**Subject: Submittal of ABWR Licensing Topical Report (LTR)
NEDO-33336 "Advanced Boiling Water Reactor (ABWR)
Stability Evaluation"**

NEDO-33336
Class I
eDRF 0000-0064-3948
June 2007

LICENSING TOPICAL REPORT
Advanced Boiling Water Reactor (ABWR)
Stability Evaluation

Figure 3 BSP Regions Illustration for Nominal Feedwater Temperature Operation

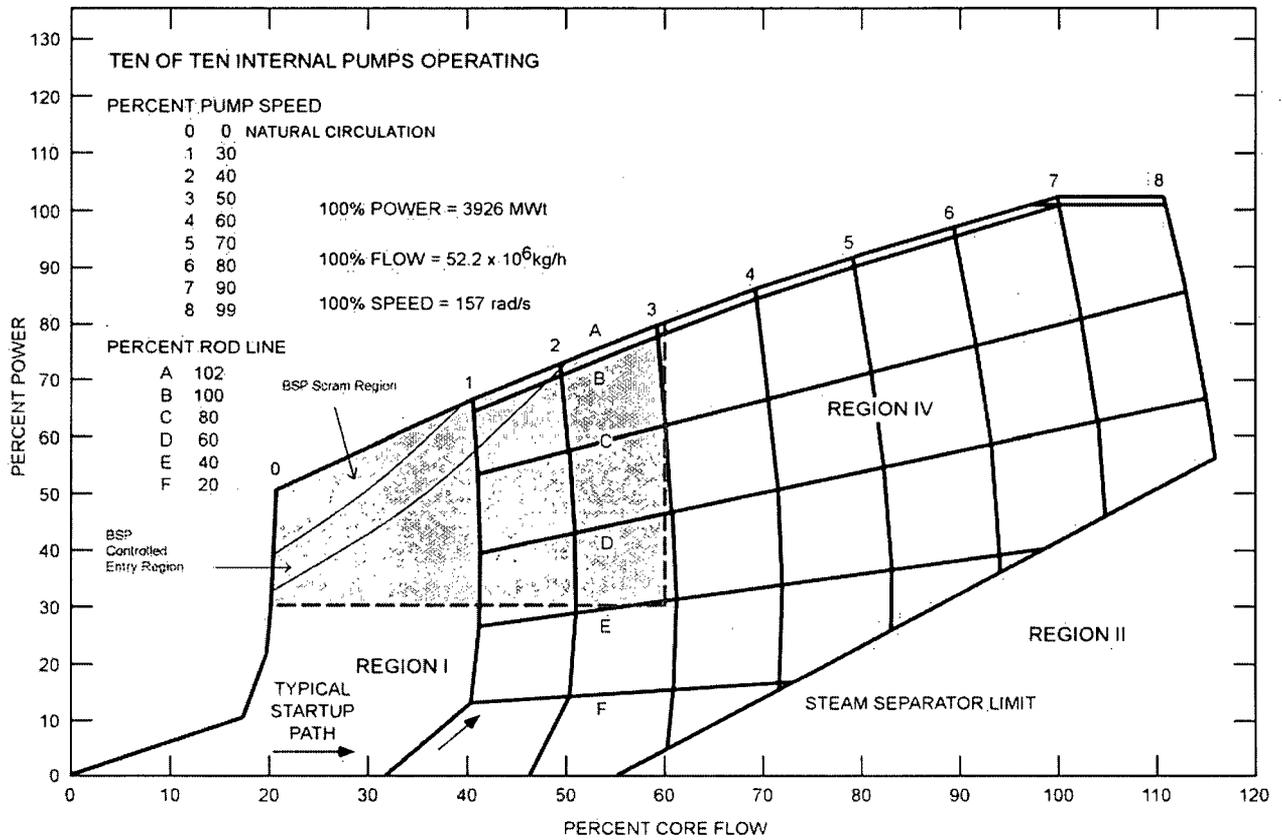
Figure 3 shows the proposed implemented BSP boundaries. In this particular case, the BSP analysis shows that the original ICA intercepts, A1-ICA, A2-ICA and B2-ICA, are more bounding than the best estimate calculated state points. Therefore, these state points, plus the ODYSY calculated state point, B2, are used to construct the BSP regions shown in Figure 3.

Figure 4.4-1 Power-Flow Operating Map Used for System Response Study

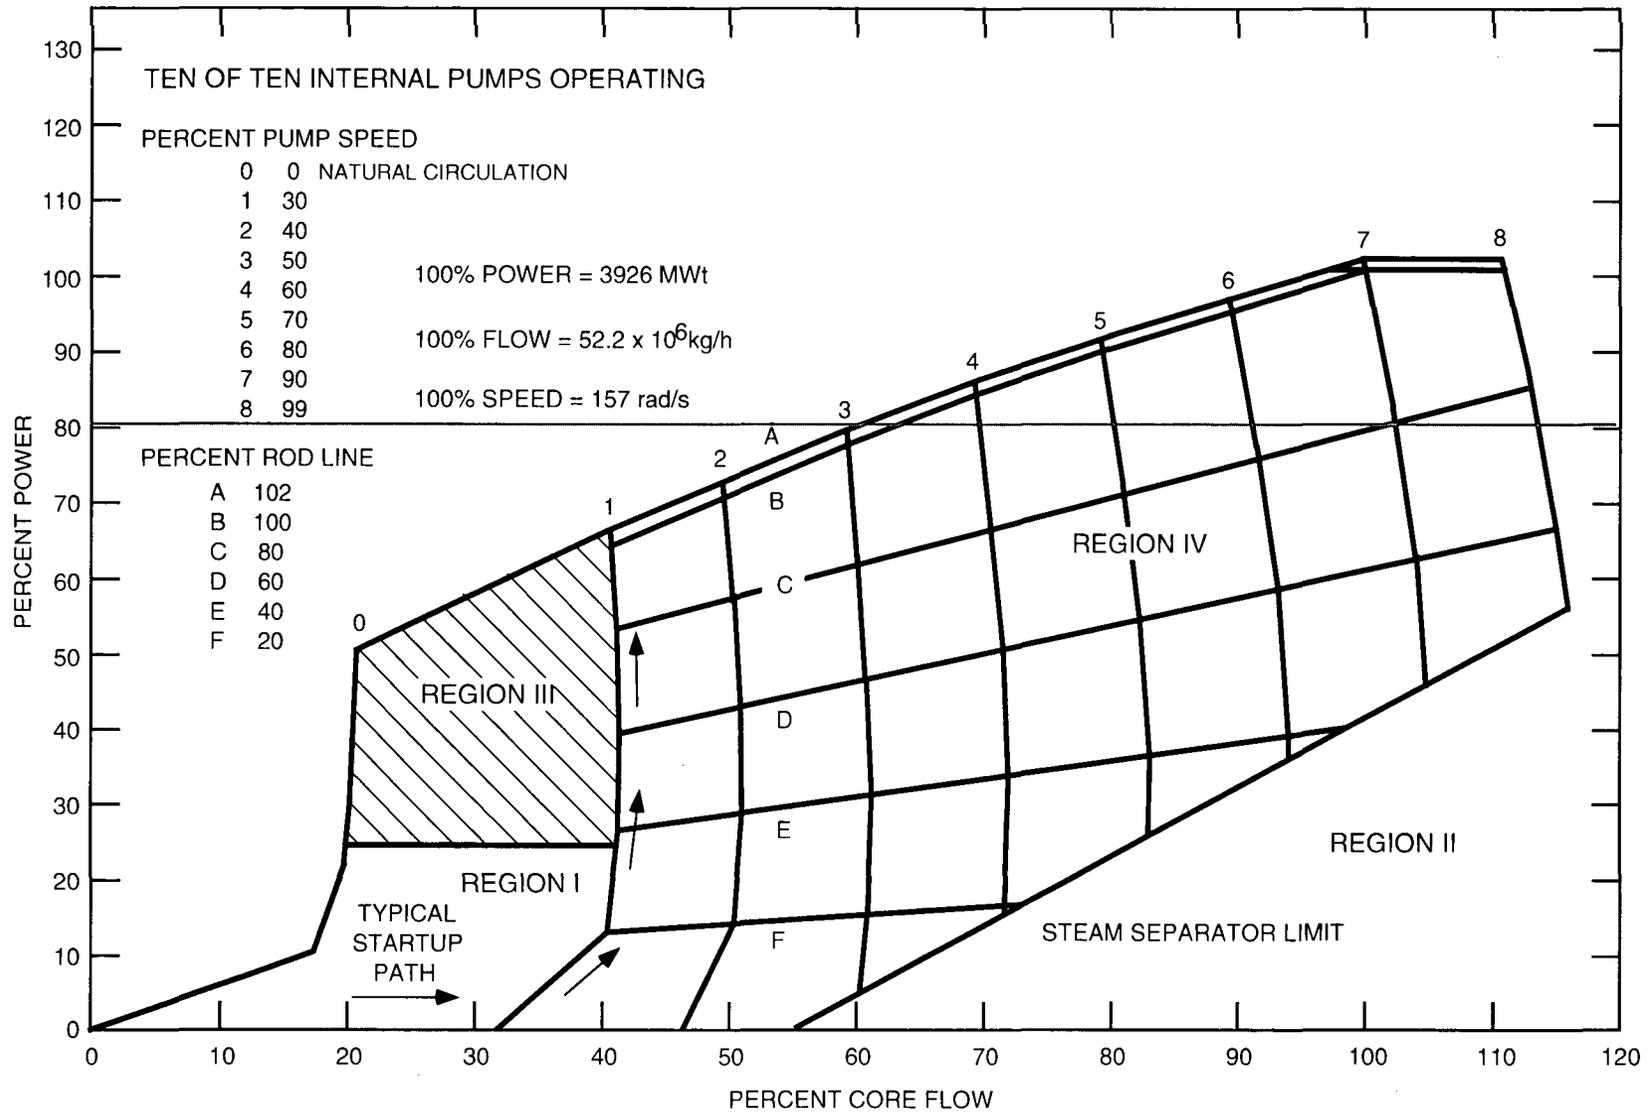
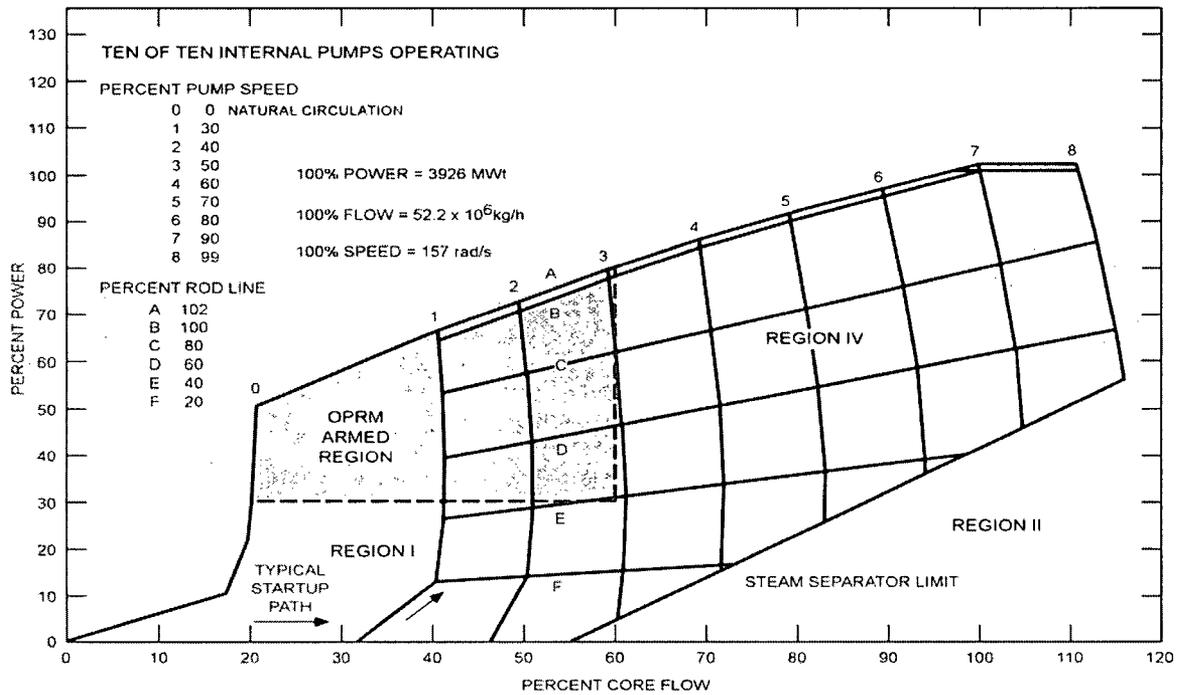
Tier 2 Figure 4.4-1 Power-Flow Operating Map Used for System Response Study

| Region I | This region defines the system operational capability with the reactor internal pumps running at their minimum speed (30%). Power changes, during normal startup and shutdown, will be in this region. The normal operating procedure is to startup along Curve 1 shown in Figure 4.4-1. |

The following limits and design features are employed to maintain power conditions shown in Figure 4.4-1:

Figure 4.4-2 Power-Flow Operating Map Used for System Response Study (9 RIPs Operation)

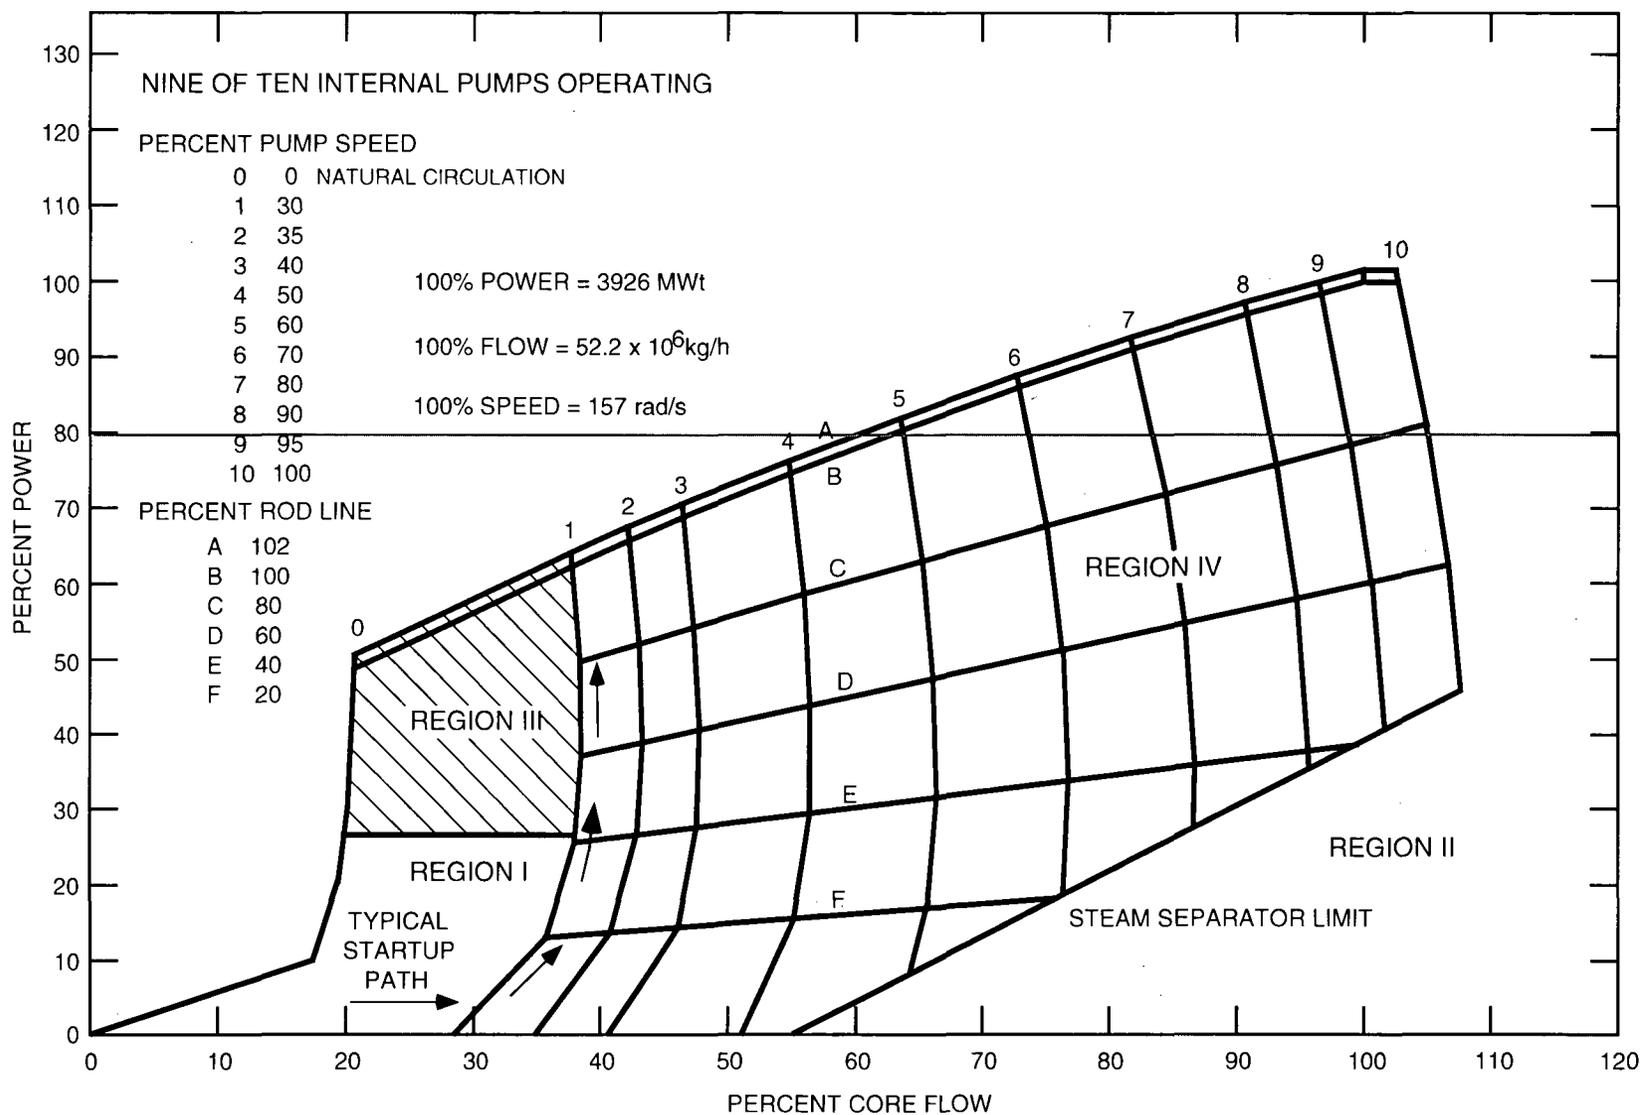
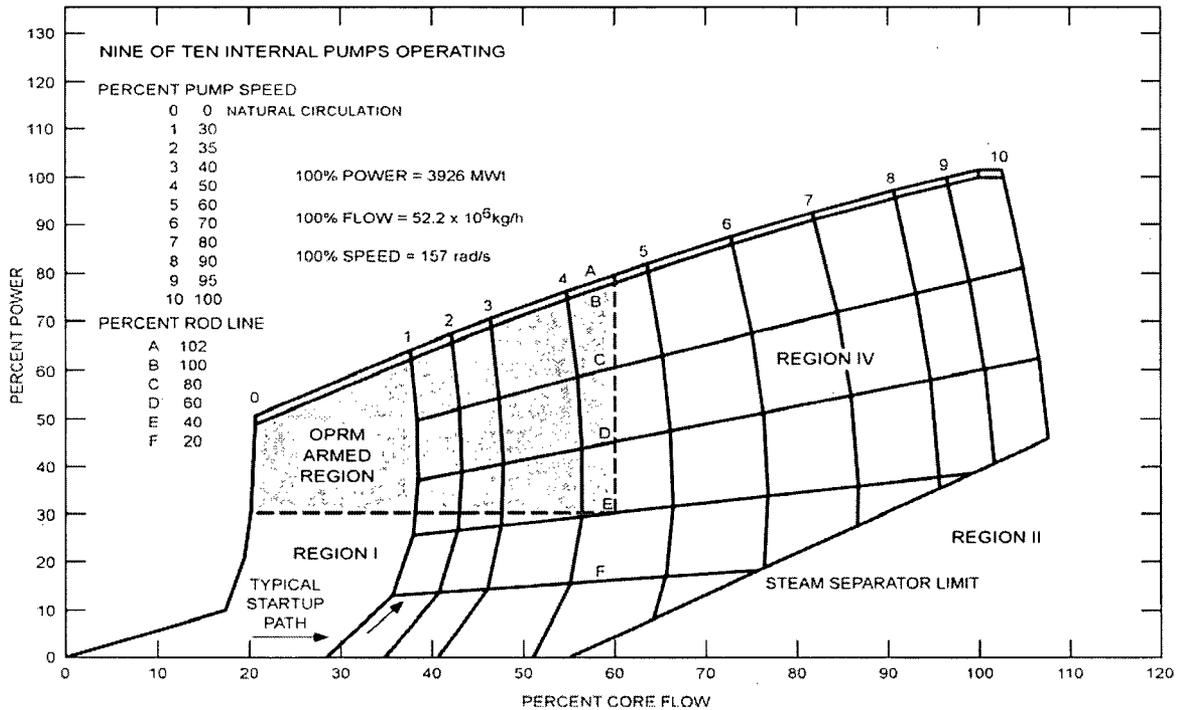
Tier 2 Figure 4.4-2 Power-Flow Operating Map Used for System Response Study
(9 RIPs Operating)

Figure 4.4-4 Stability Controls and Protection Logic

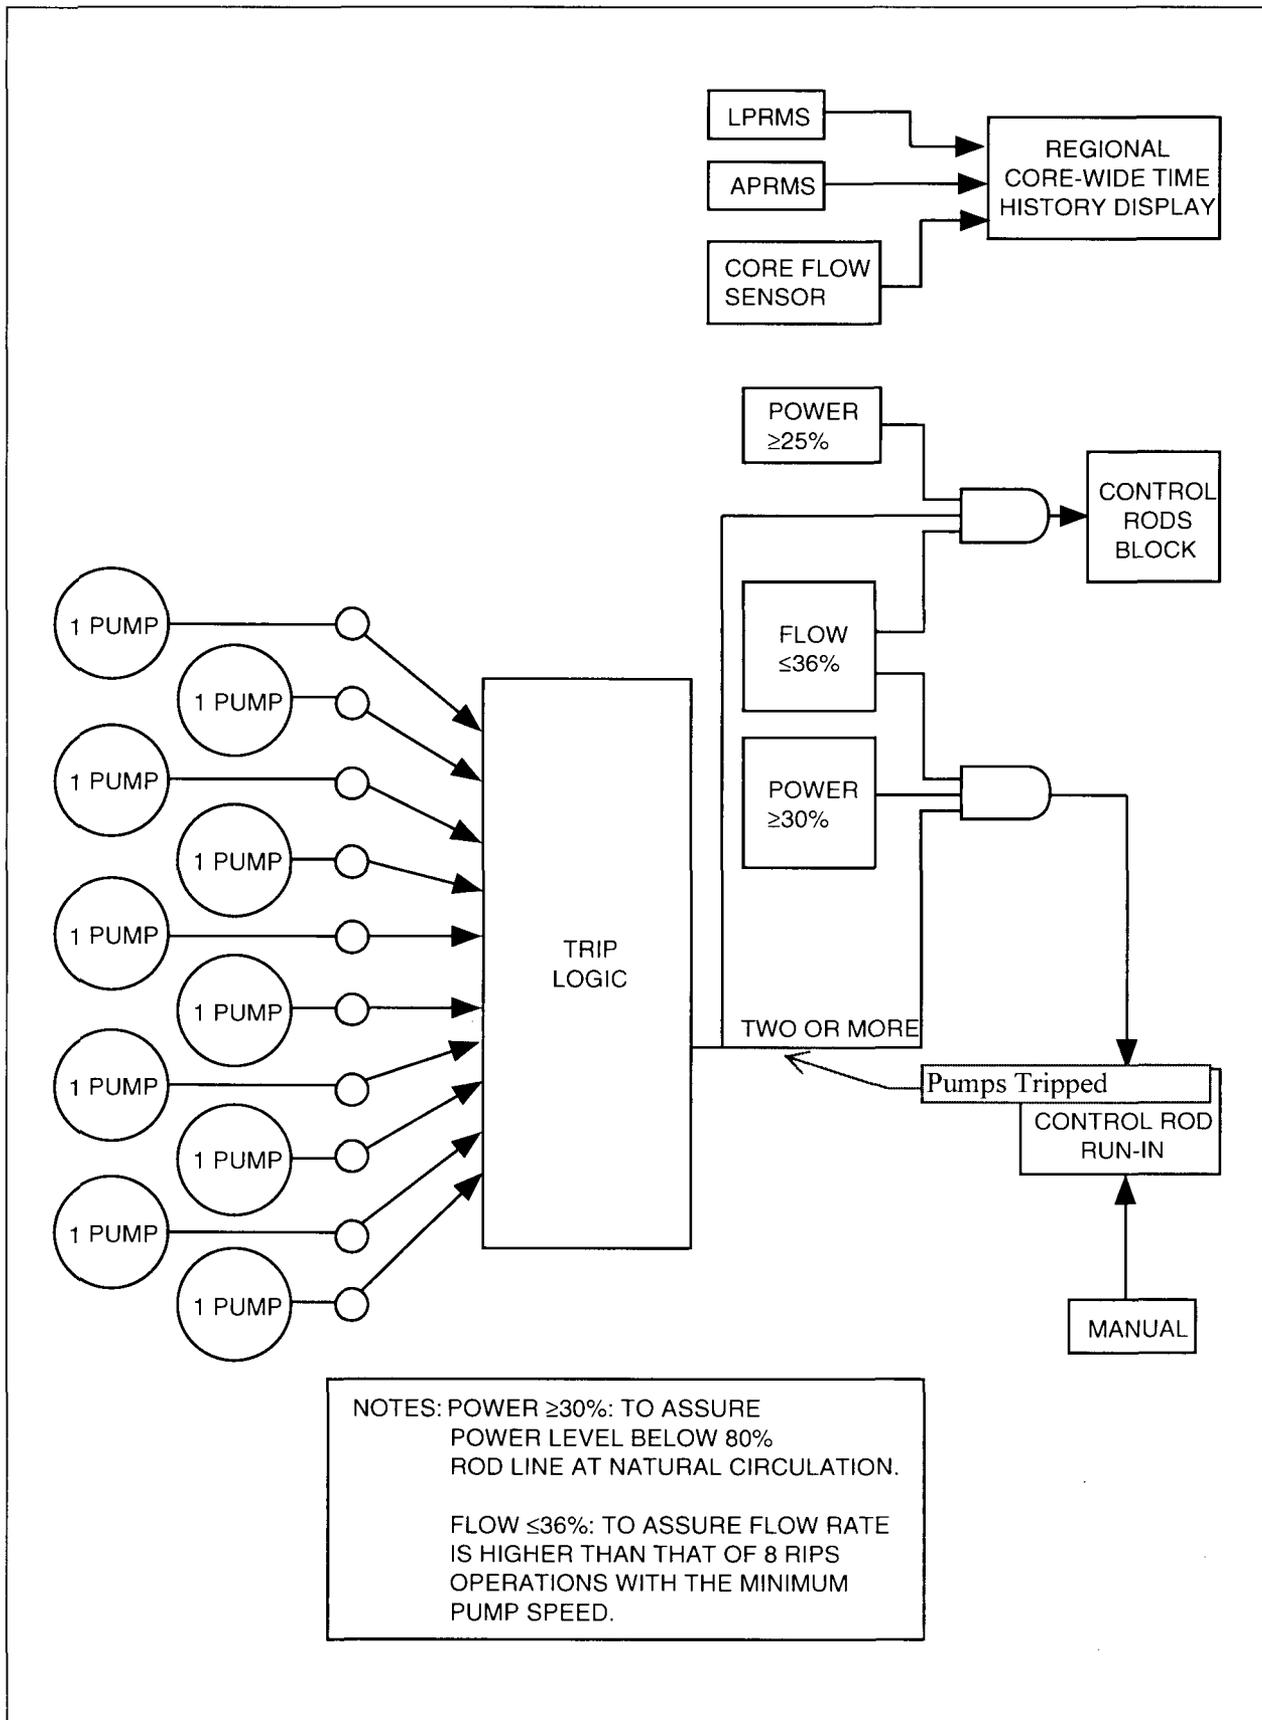
Tier 2 Figure 4.4-4 Stability Controls and Protection Logic

Furthermore, automatic logics (Figure 4.4-4) which prevent plant operation in the region with the least stability margin is also implemented. This design is similar to Option I-A, one of long-term solutions considered by the BWROG. In addition, in order to meet the stability design requirements specified in the ALWR Utility Requirements Document, Option III, LPRM based Oscillation Power Range Monitor (OPRM), which is also one of the long-term solutions considered by the BWROG, has been implemented in the ABWR design.
